# ALERT SERVICE BULLETIN

NO. 206L-09-162

**SUBJECT:** HYDRAULIC SERVOACTUATOR P/N 206-076-062-103, INSPECTION OF.

FLIGHT CONTROLS – HYDRAULIC SERVOACTUATOR, PART NUMBER 41001520-009

Hydraulic Servo Actuator P/N 41001520  
Figure 1

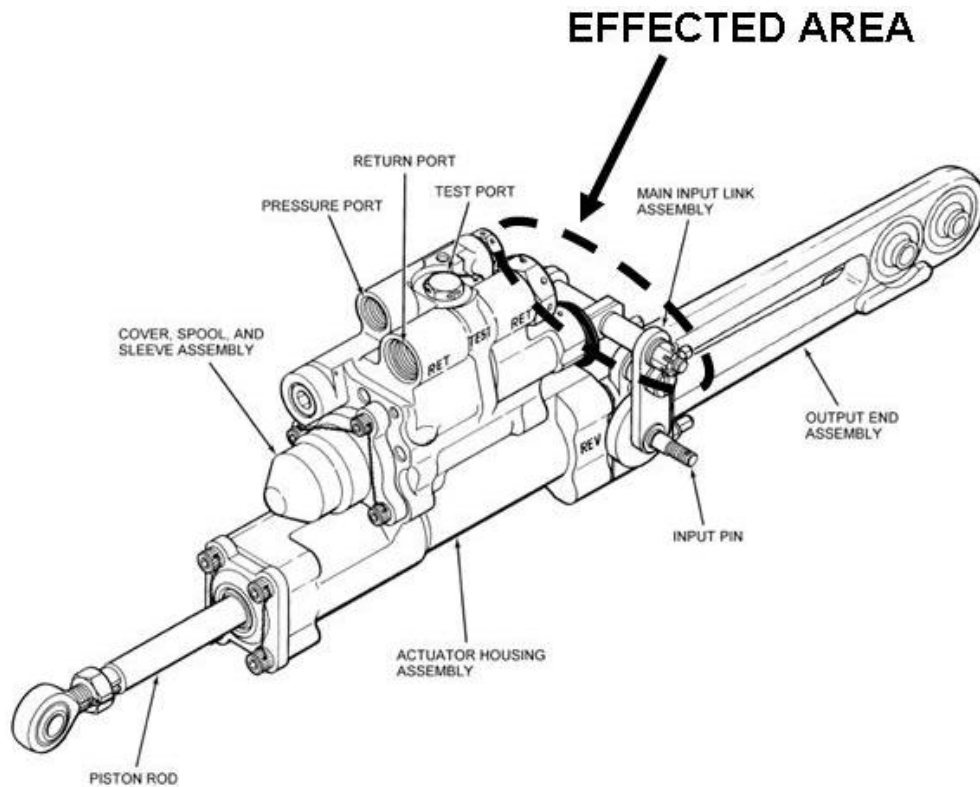
A small number of hydraulic servoactuators 41001520-009 have been discovered with limited clearance between two bolt flanges on output end assembly 41009473-101 or -102 and spacer 41003289. This limited clearance has the potential to create increased pilot input force (see Figures 1 and 2).

Wear Indications  
Figure 2

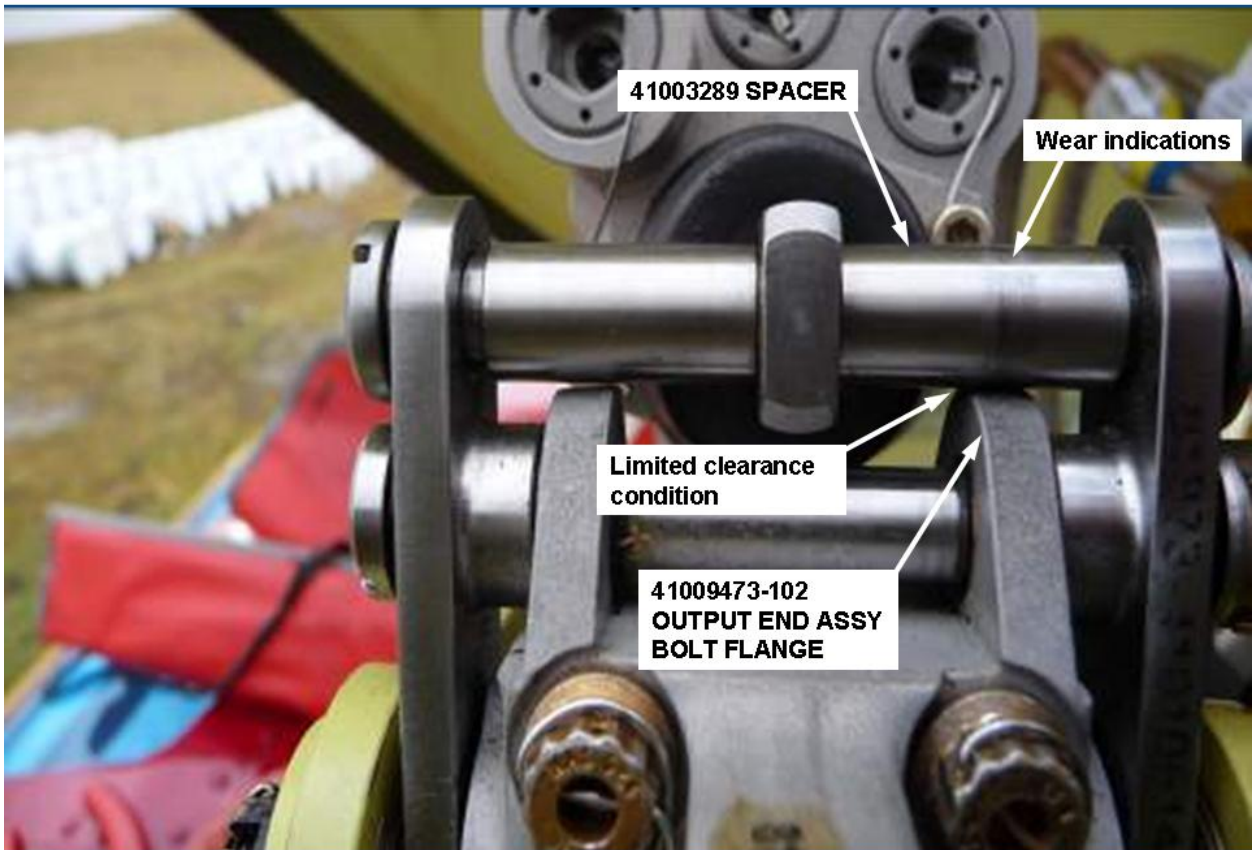
4. If the hydraulic servo actuator has a serial number affected by this bulletin, proceed as follows.
5. Verify that spacers 41003289 (two locations) show no evidence of contact as shown on Figure 2.

6. If the spacer shows evidence of contact at one of the two locations and does not rotate freely or offers sufficient resistance so it cannot be rotated by fingers, remove the hydraulic servo and send to a HRT-approved service facility for rework before further flight. If the condition described in this step is found, but no excessive force or feedback is reported by the pilot, a one time ferry flight to nearest maintenance facility is allowed. Make appropriate entry in the helicopter and component records to show accomplishment of this bulletin and indicate findings.

7. If the spacer shows evidence of contact but rotates freely at both locations, send the servo actuator to a HRT-approved service facility within the next 600 flight hours or 6 months whichever comes first for accomplishment of Part II of this bulletin. Make appropriate entry in the helicopter and component records to show accomplishment of this bulletin and indicate findings.

Clearance Data  
 Figure 3

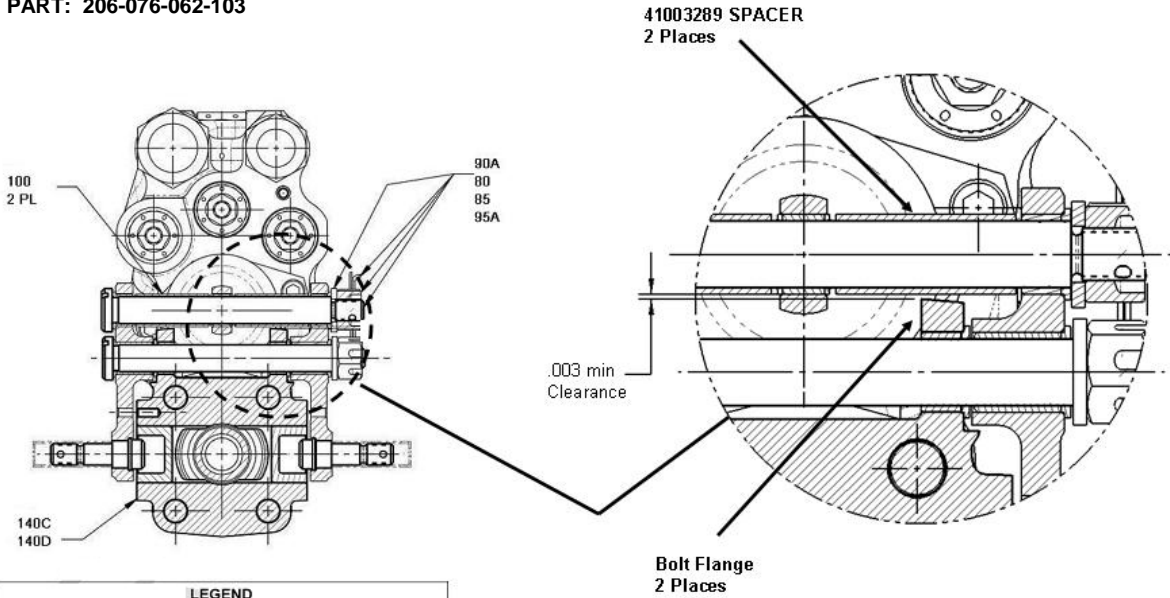
8. If the spacer does not show evidence of contact, use a feeler gauge and verify the clearance between the output end assembly bolt flange and the upper bolt spacer 41003289 as shown on Figure 3.

9. If the clearance is less than 0.003 inch, send the servo actuator to a HRT-approved service facility within the next 1200 flight hours or 12 months whichever comes first for accomplishment of Part II of this bulletin. Make appropriate entry in the helicopter and component records to show accomplishment of this bulletin and indicate findings.

Rework Instructions  
Figure 4

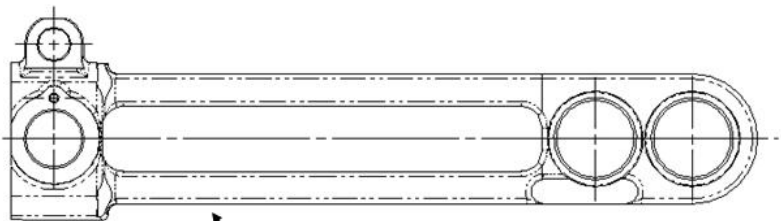
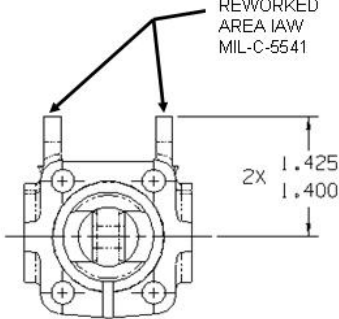
- B. Part II. Output assembly rework. To be accomplished by HRT-approved service facility:
1. Whenever hydraulic servo actuator 41001520-009 (Bell Helicopter P/N 206-076-062-103) prior to serial number HR1672 and without the identification "MOD 67-02" located on the underside of the 41009473-102 or -101 Output End is received for overhaul or repair, rework 41009473-102 or -101 Output End to following instructions and Figure 4.

2. Rework bolt flange height (2 places) to 1.400-1.425 dimension shown on Figure 4. Rework form may be a straight cut or a blended radius.
  3. Identify with identification "MOD 67-02" located on the underside of the 41009473-102 or -101 Output End as shown on Figure 4.

4. Chem-film reworked and identification area in accordance with MIL-C-5541 Class 1A.

IDENT WITH "MOD 67-02"  
.09 MIN HIGH CHARACTERS  
APPROX WHERE SHOWN  
CHEM ETCH OR LASER ENGRAVE  
CHEM FILM REWORKED  
AREA IAW MIL-C-5541

CHEM FILM  
REWORKED  
AREA IAW  
MIL-C-5541
